3.0 LIMITING CONDITION FOR OPERATION (LCO) APPLICABILITY

The information in this section of the reference ABWR DCD, including all subsections, is incorporated by reference with the following departure.

STP DEP 16.3-1

Figure B 3.3.1.1-1 ADS Inhibit Instrumentation Channels

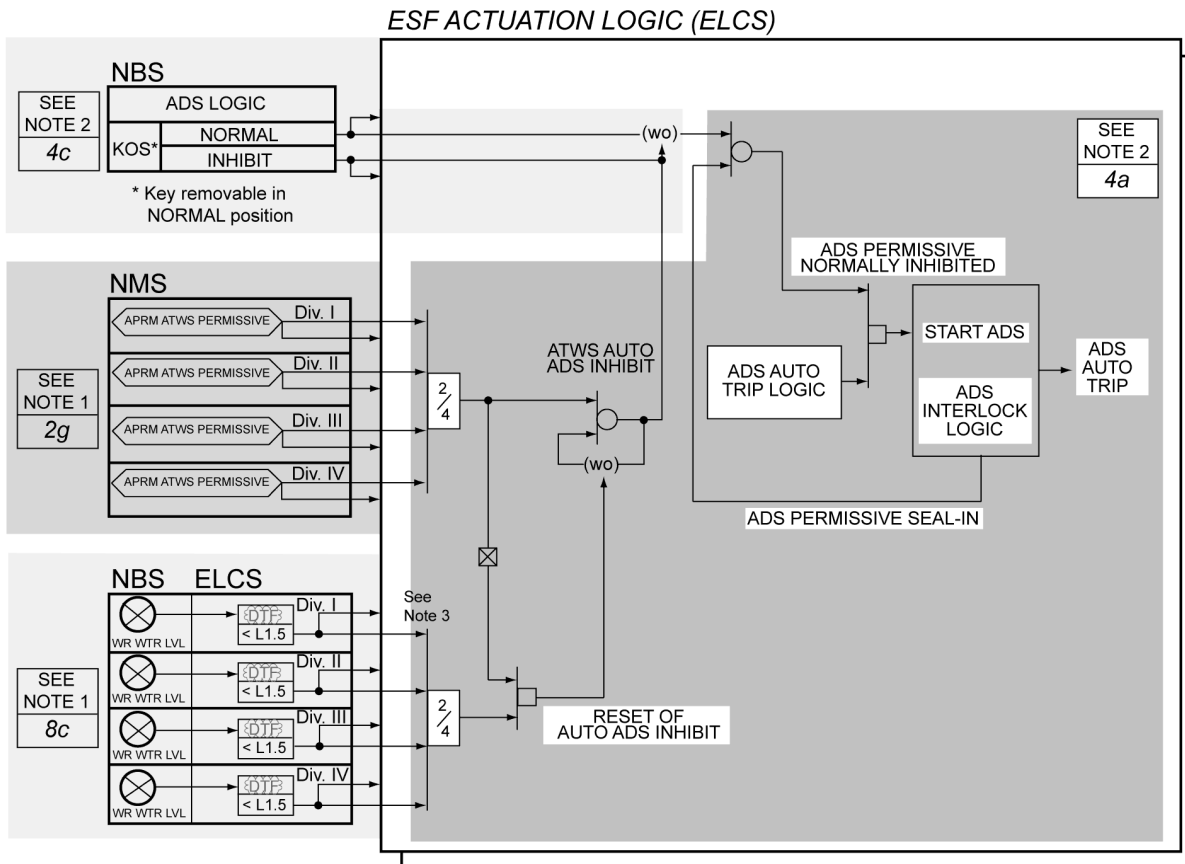
STD DEP T1 3.4-1

Figure B 3.3.1.1-2 RCW/RSW HX Room Leak Detection Instrumentation Channels

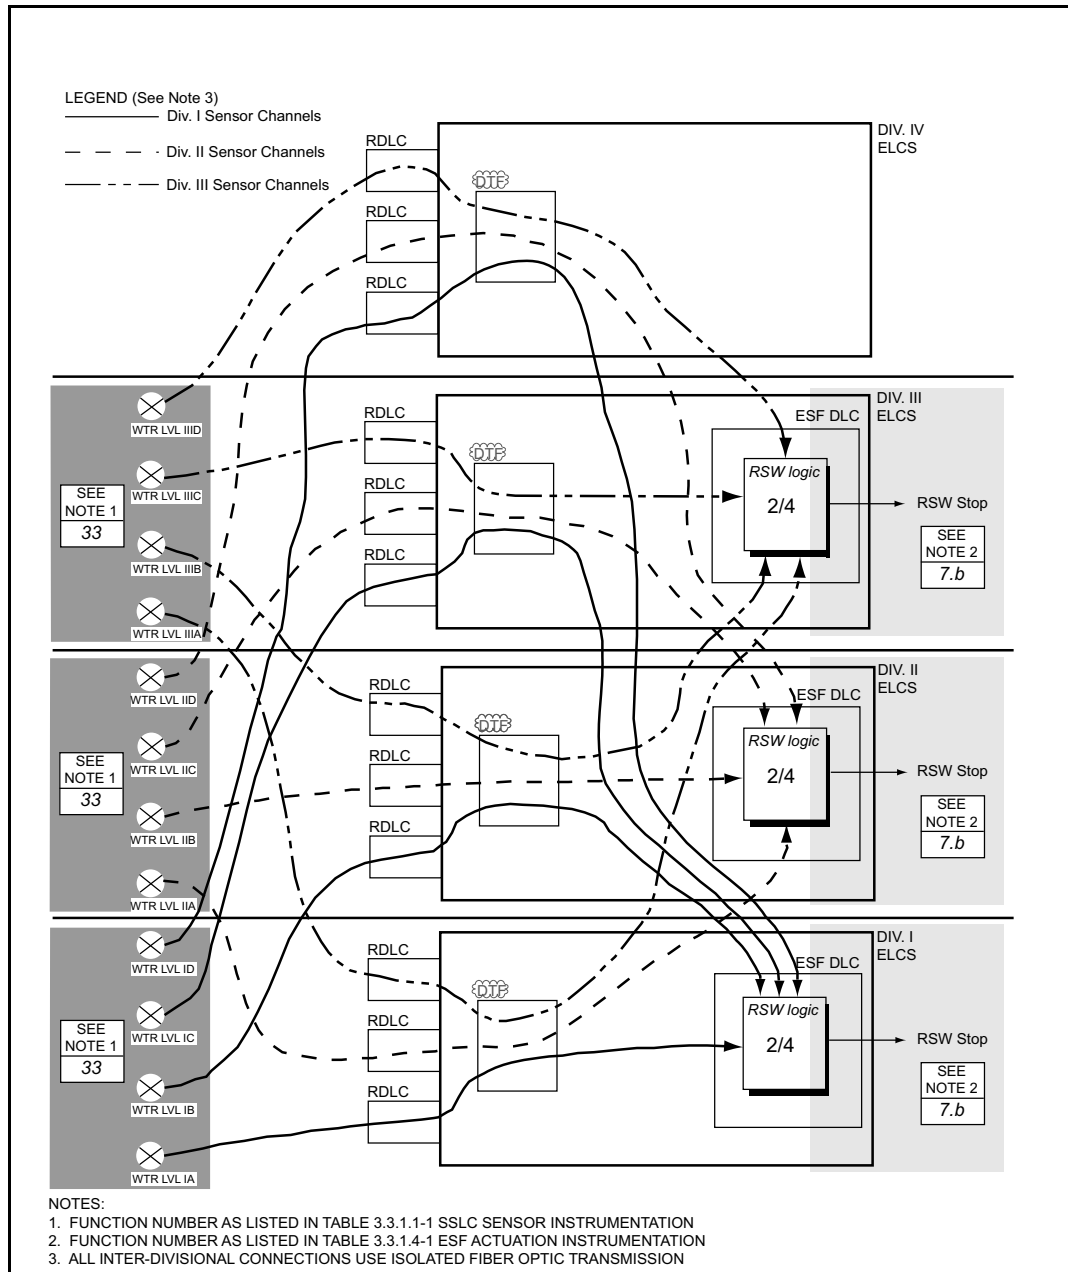
STD DEP T1 3.4-1

Figure B 3.3.1.4-1 ESF Actuation Channel Structure for Containment Isolation, ESF Support

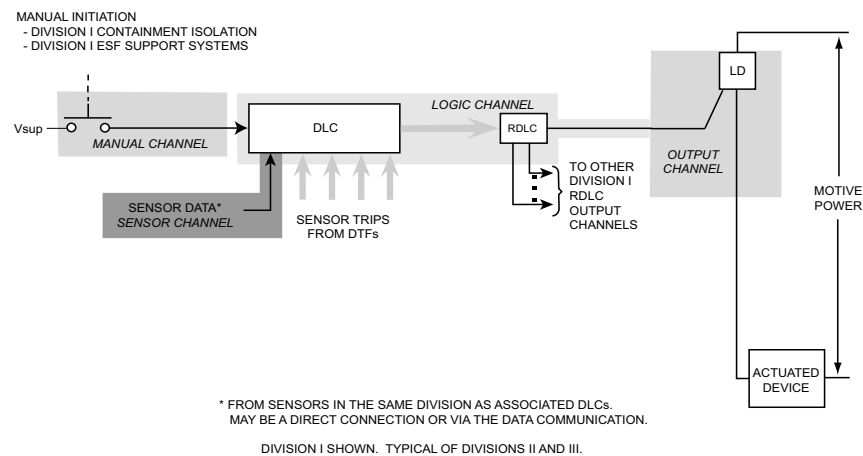
STD DEP T1 3.4-1

Figure B 3.3.1.4-2 ESF Actuation Channel Structure for LPFL B, C, HPCF B, RCIC

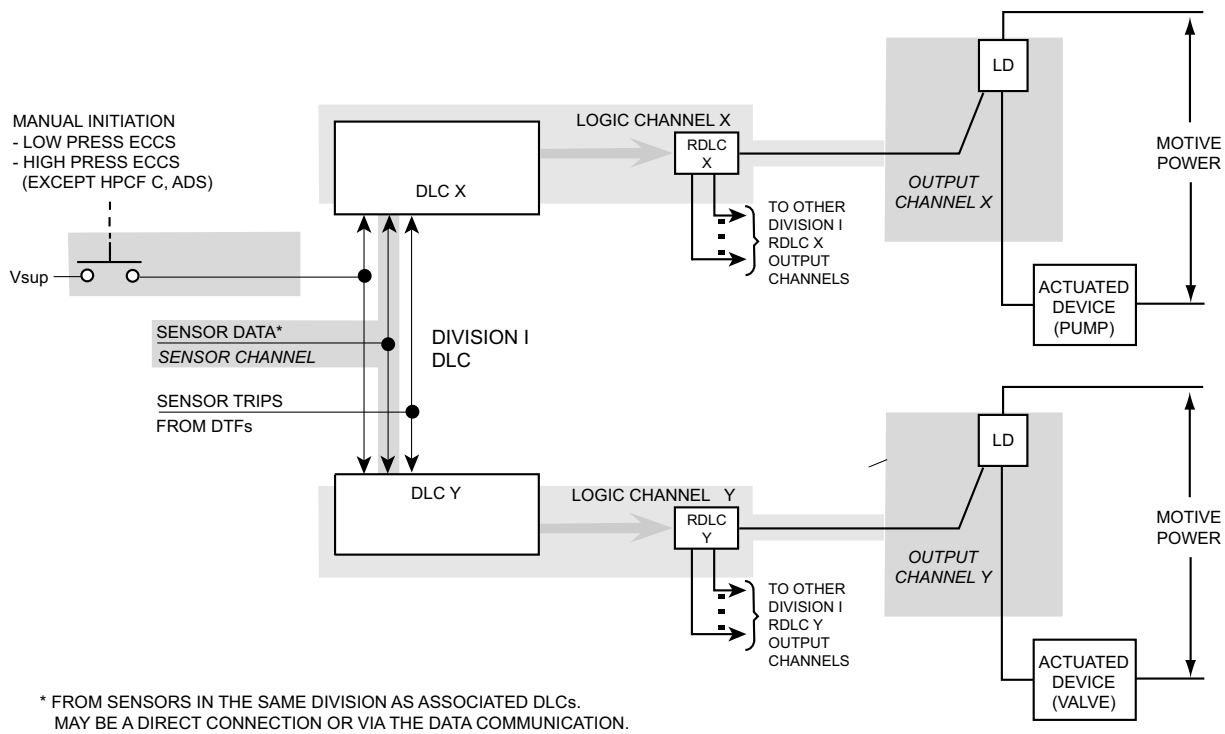
STD DEP T1 3.4-1

Figure B 3.3.1.4-4 ESF Actuation Channel Structure for ADS

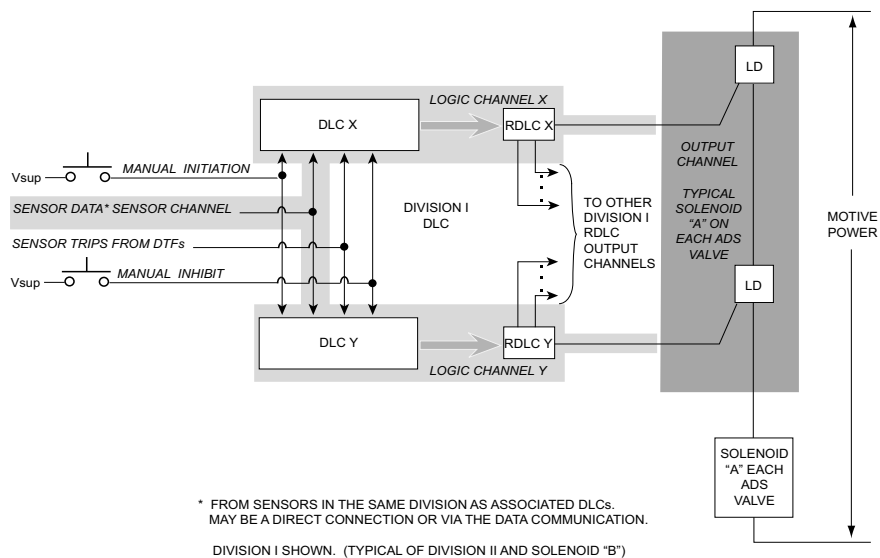
STD DEP T1 3.4-1

Figure B 3.3.4.1-1 ATWS and EOC-RPT Instrumentation Channels

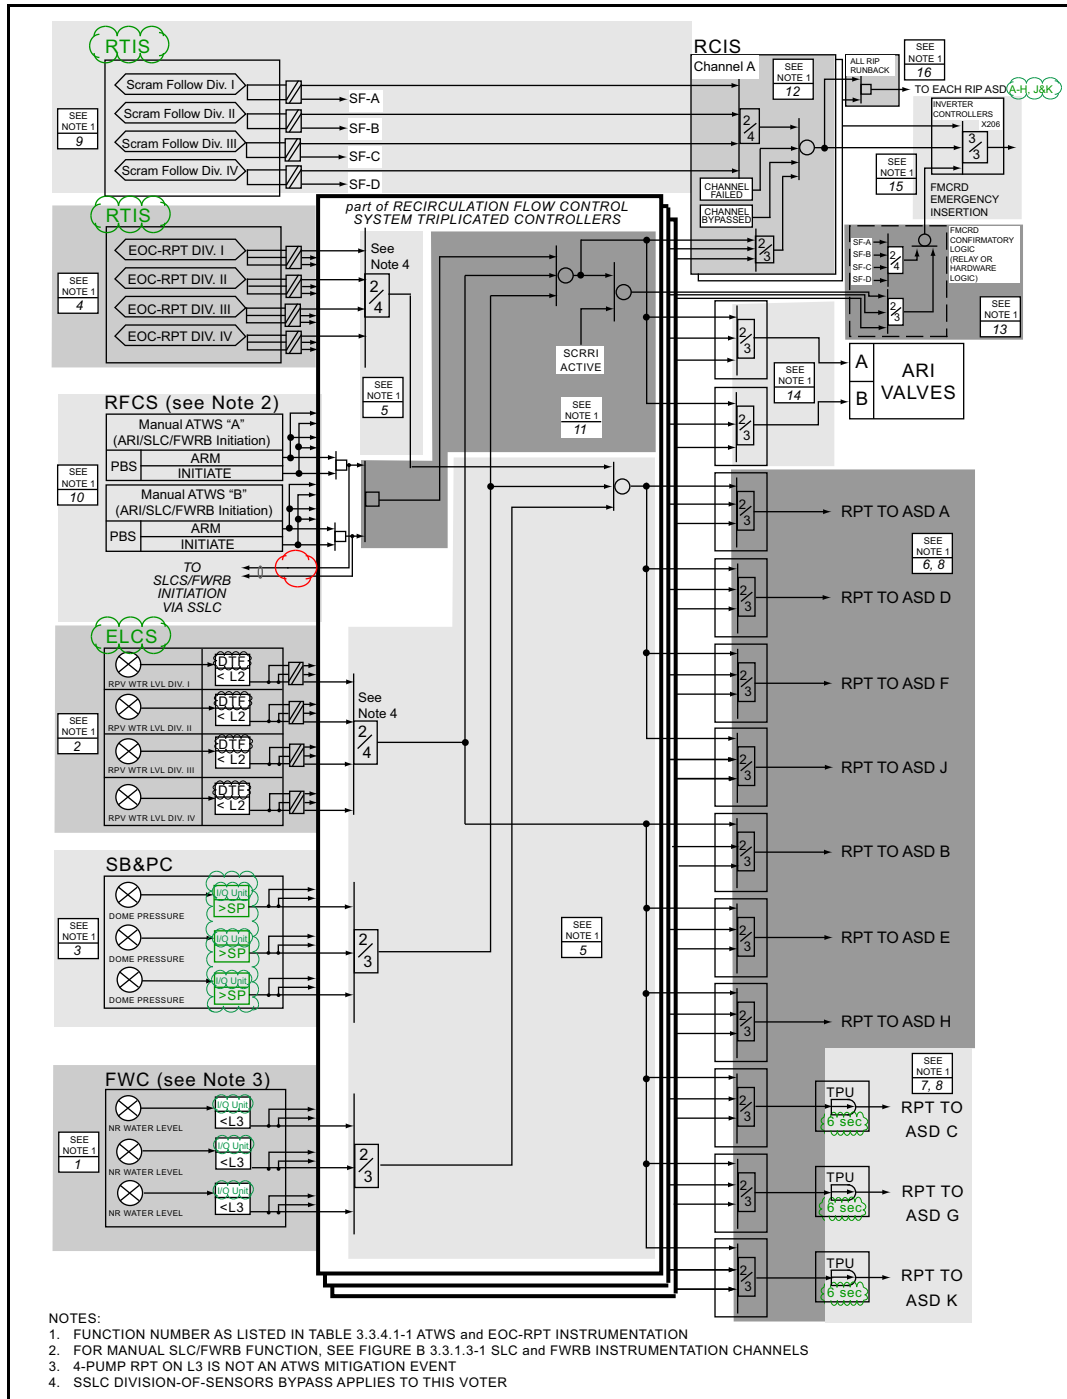
STD DEP T1 3.4-1
